Technical Service Bulletin

Subject: IGNITION DOES NOT TURN OFF WHEN PRESSING START / STOP BUTTON	Bulletin No.: 05-001/19
	Last Issued: 02/15/2019

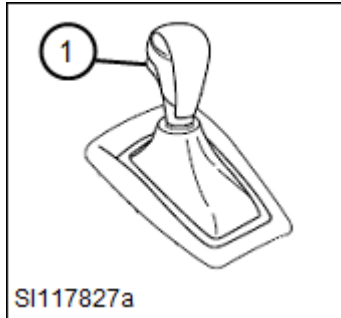
When pressing the START/STOP button in very cold weather, the ignition may not turn off on some vehicles equipped with a lock release button (1) on the selector lever knob. Although the selector lever is in the "P" position and the engine shuts off normally, the ignition may stay on (in accessory mode).

This may be caused by the lock release button in the selector lever knob sticking in the pressed position. An improper production process is causing an internal part to expand with moisture and interfere with other parts. To eliminate this concern, the production process has been modified.

2. Replace the shift selector knob with a modified one according to the instruction in MGSS (AUTOMATIC TRANSAXLE SHIFT MECHANISM REMOVAL/INSTALLATION).
